# The Calcutta Gazette

### NOTICES TO MARINERS.

The following Notices are republished for general information.

**Chart affected.**—No. 2465, Plan of Egeron strait.

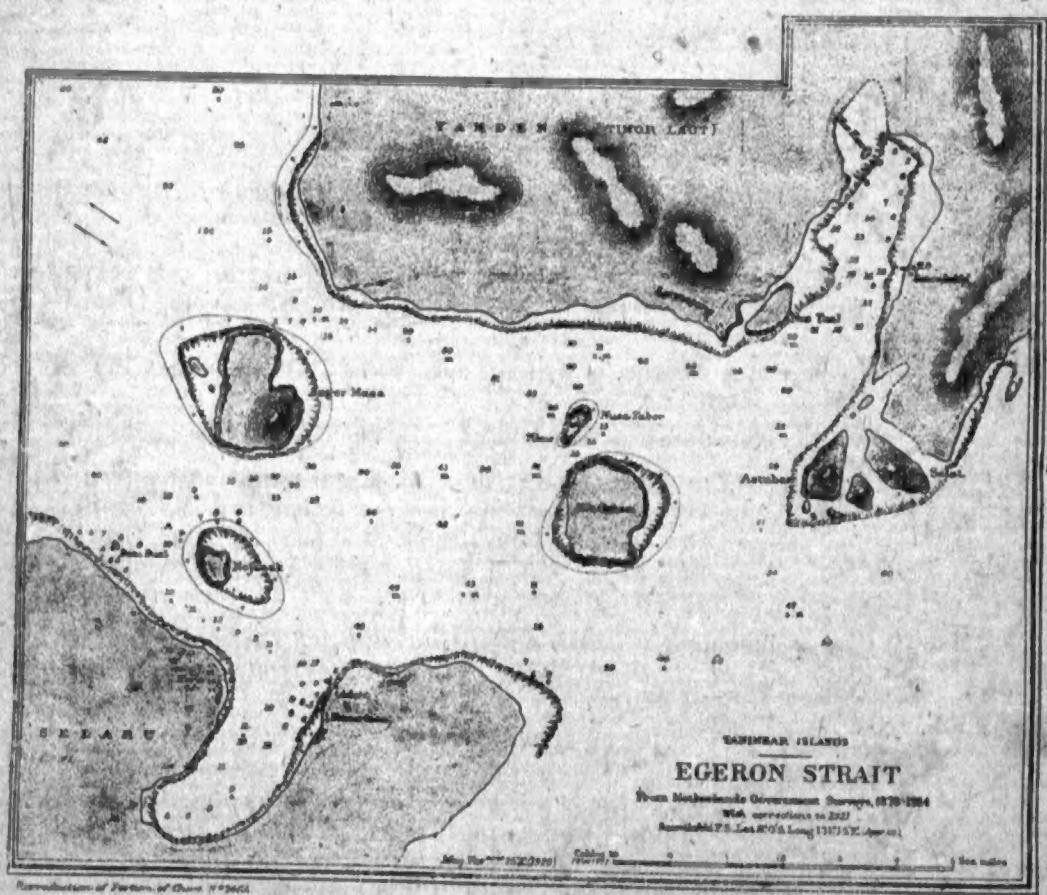
**Details.**—The accompanying reproduction of the plan of Egeron strait on chart No. 2465 shows the necessary corrections to that plan with regard to depths, coastline and shore reefs.

*Charts affected.*—No. 2760, Aceh head to Chingkuk bay.

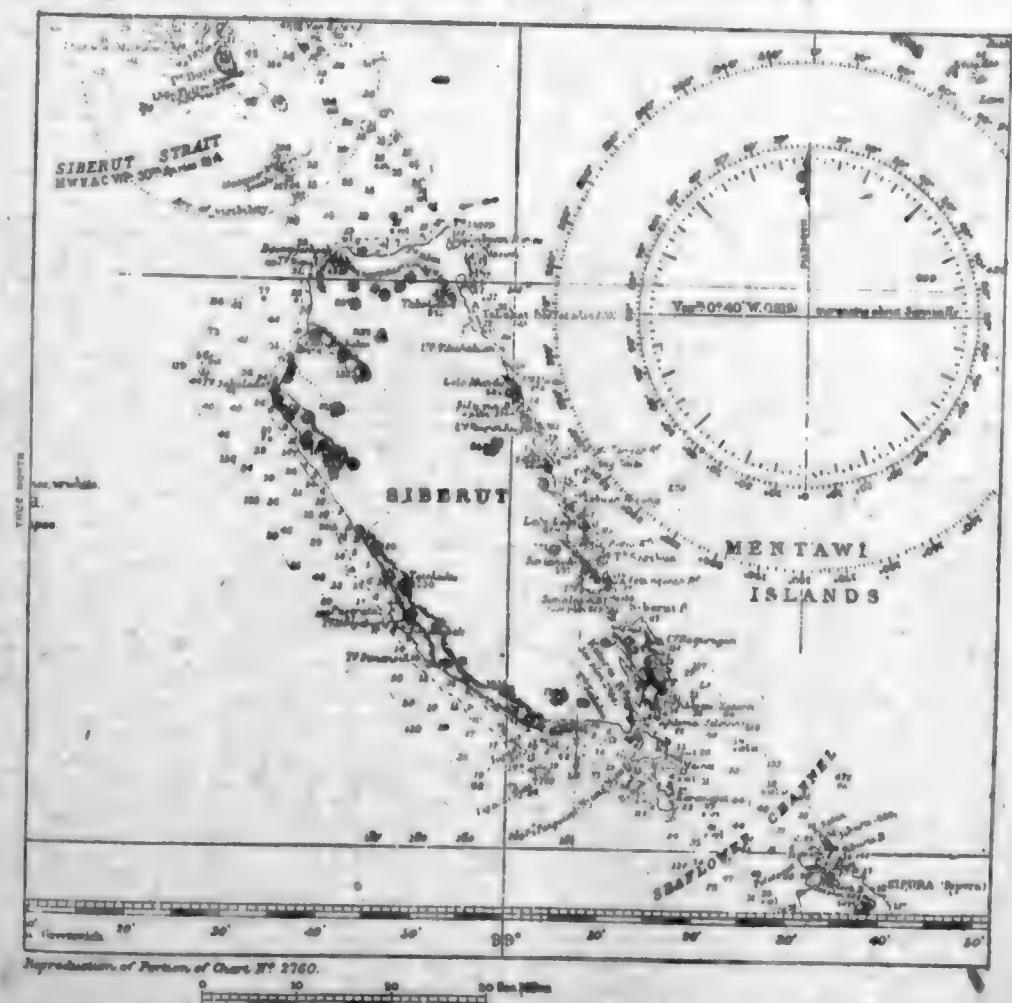
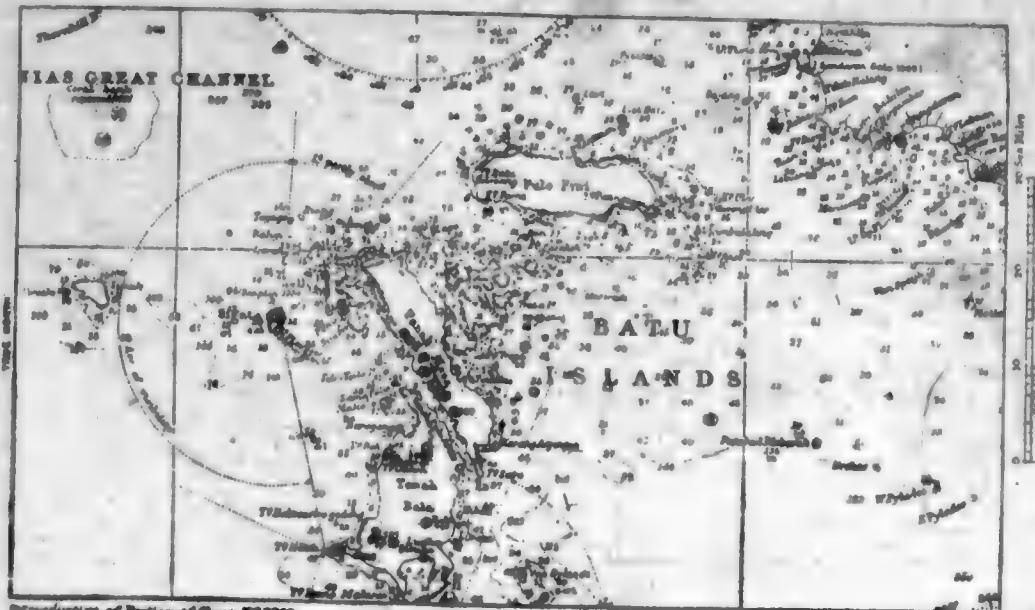
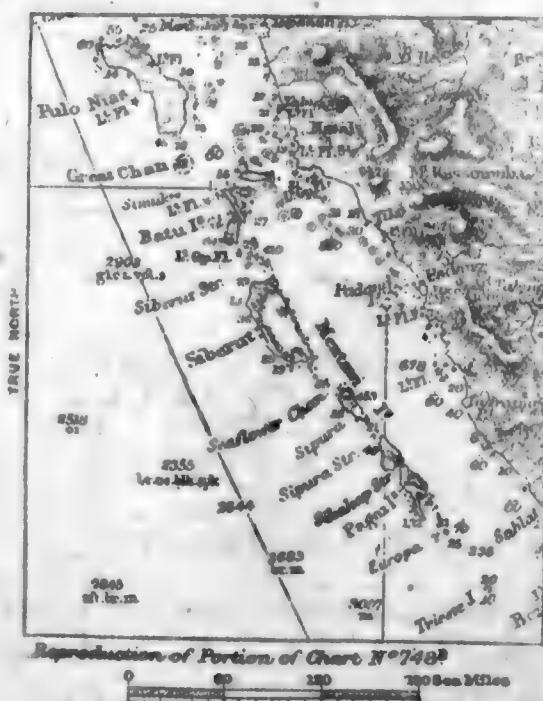
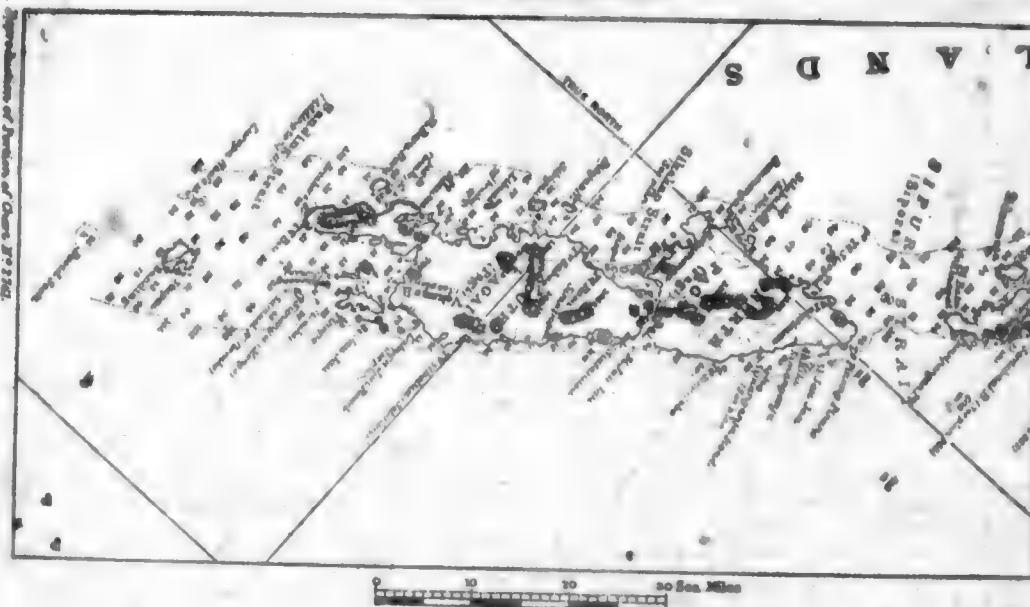
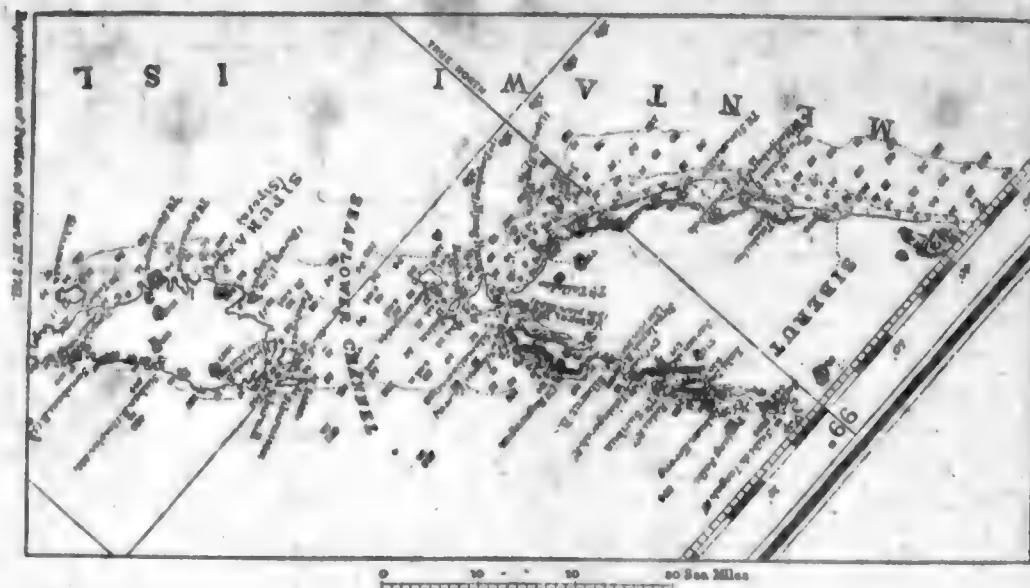
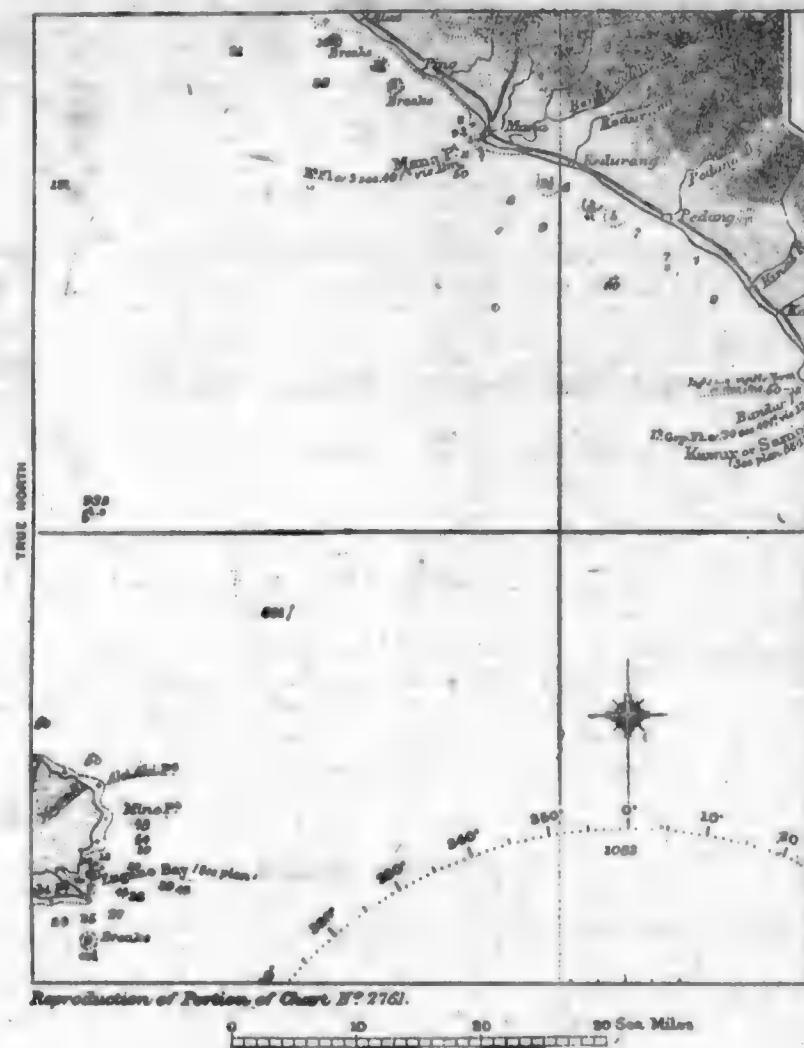
*Details.*—Amendments to the charts with regard to shoals and depths between the two places mentioned above are shown on the accompanying reproduction of a portion of chart No. 2760; certain minor amendments to the topography are also shown on this reproduction.

*Details.*—Extensive amendments to the charts with regard to Batu and Mentawi islands and the depths and shoals in vicinity, embodying the latest information received, are shown on the accompanying reproductions of portions of charts Nos. 2760, 2761 and 748b.

*Chart affected.*—No. 2983. Funafuti atoll, with plan.

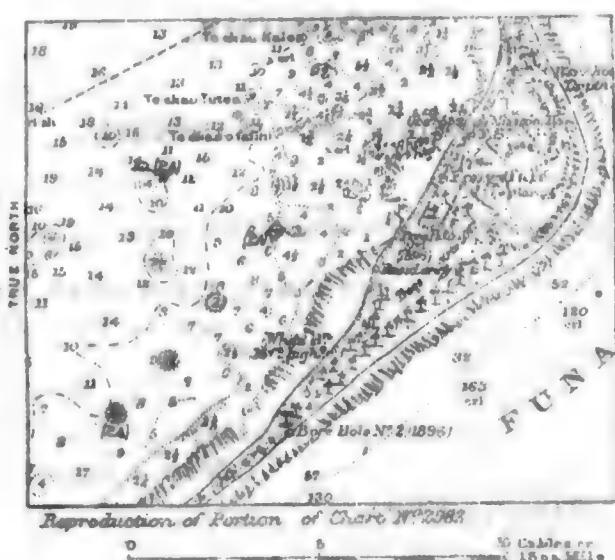
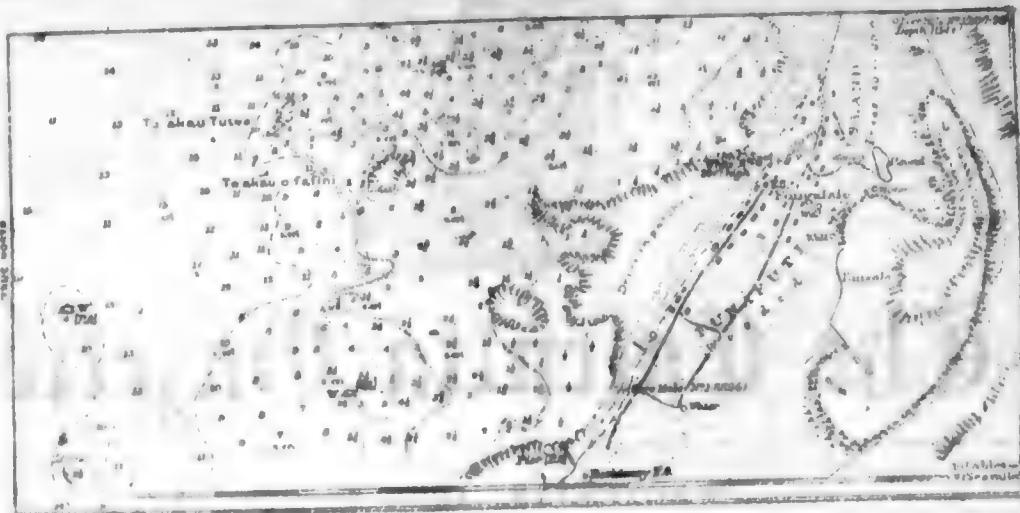
*Details.*—The accompanying reproductions of portions of chart No. 2983 and the inset plan of Fongafale anchorage show the necessary corrections to that chart with regard to shoals, buoys and beacons, etc.

*Charts affected.*—No. 967, Palawan island.

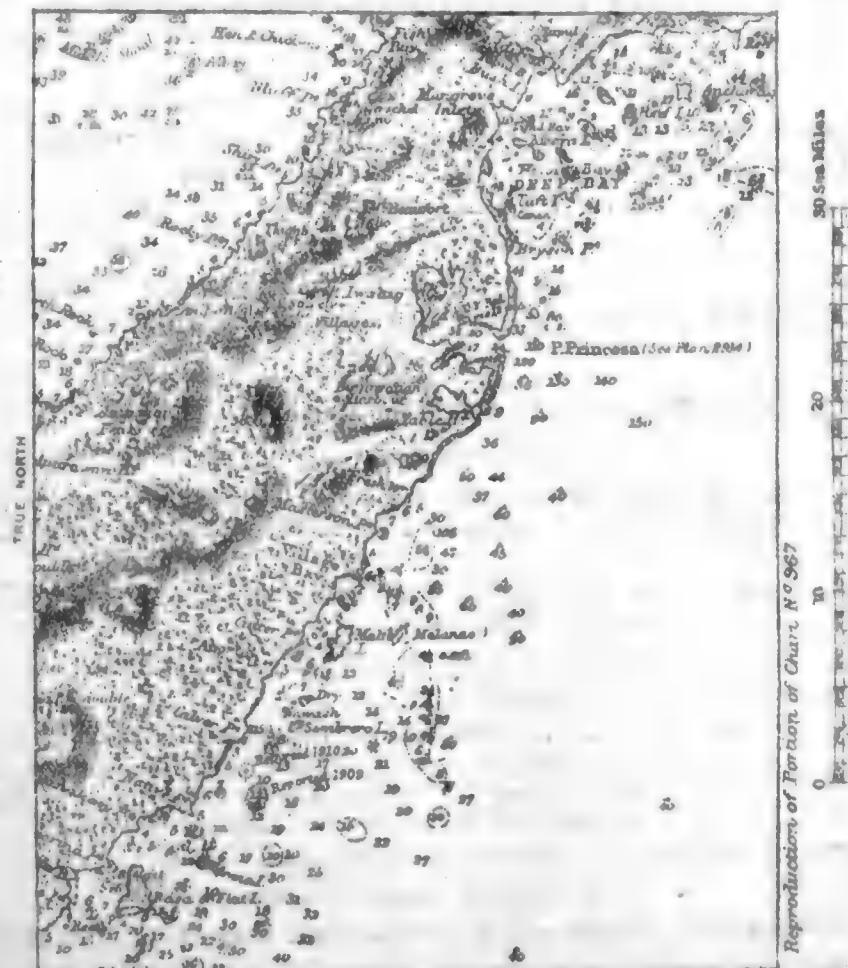
*Details.*—Amendments to the charts with regard to shoals between Rasa or Flat island and Deep bay, embodying the latest information, are shown on the accompanying reproduction of portions of charts Nos. 967 and 2660b.
